Village of Bayside
9075 N. Regent Rd.
Architectural Review Committee Meeting
July 1, 2019
Village Board Room, 6:00pm

ARCHITECTURAL REVIEW COMMITTEE AGENDA

VILLAGE CODE REVIEW

PLAT OF SURVEY

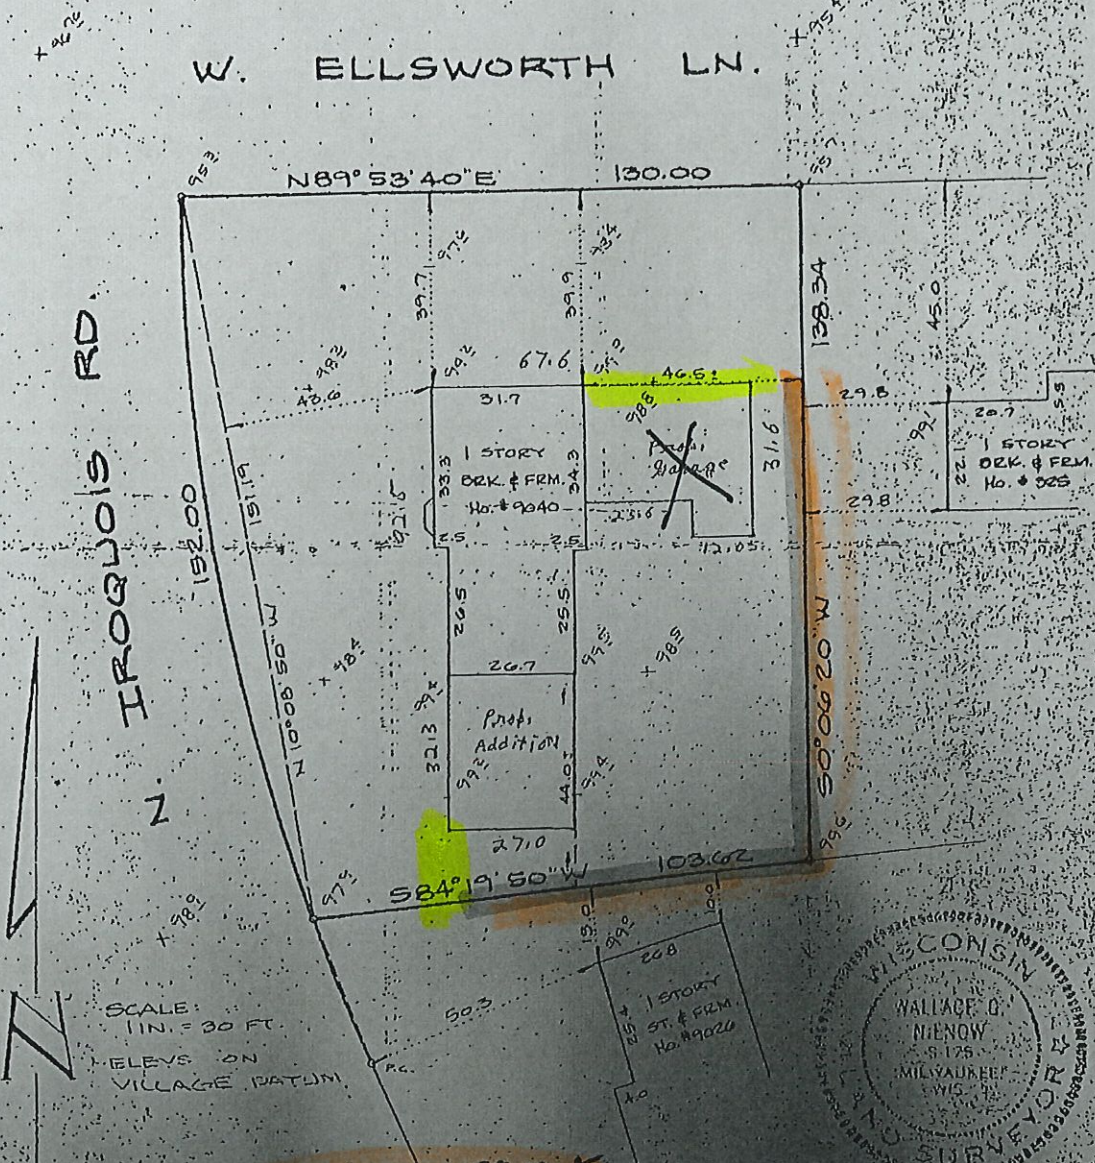
PROJECT SUMMARY:
40 ft of new fence to connect existing fence structures. Wood fence, 4 ft tall, 3" openings between fence boards.

25% open design complies with village code requirements below.

PROPOSED FENCE TYPE AND LENGTH COMPLY

PROPOSED HEIGHT COMPLIES

PROPOSED MATERIAL / FINISH COMPLIES

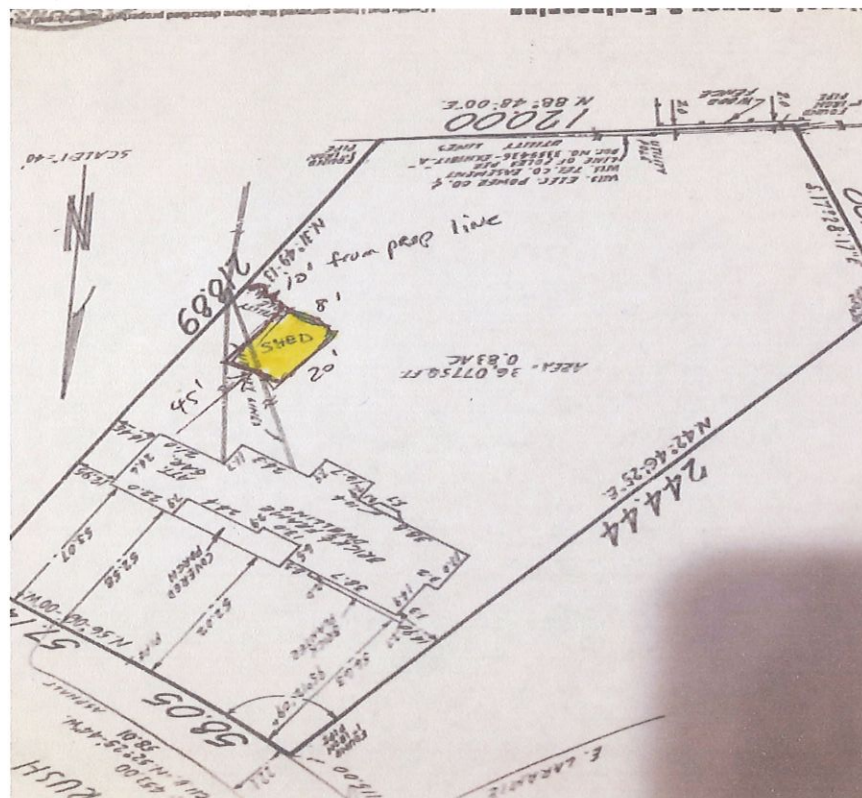
Shed location complies with setback requirements.

NEW SHED LOCATION COMPLIES WITH VILLAGE CODE.

Color matches nicely – style similar

Location will be 10' from property line

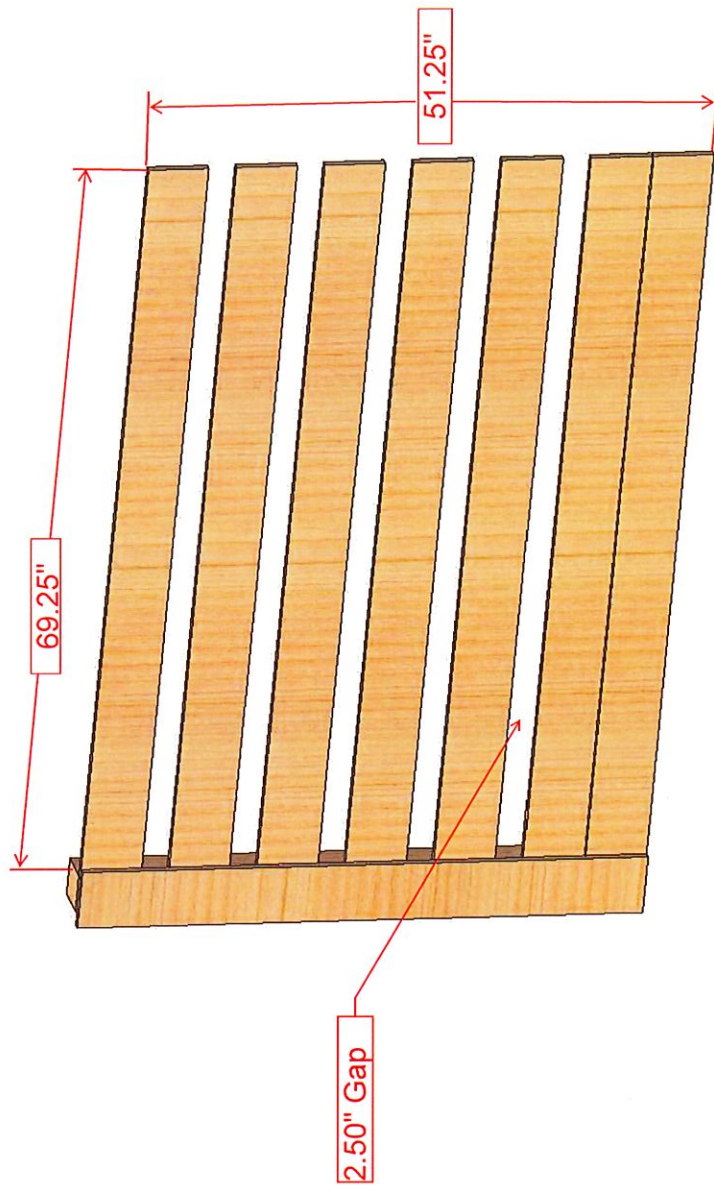
Total property perimeter = 490 ft.

25% open design complies with village code requirements below.

PROPOSED FENCE TYPE AND LENGTH COMPLY

PROPOSED HEIGHT COMPLIES

PROPOSED MATERIAL / FINISH COMPLIES
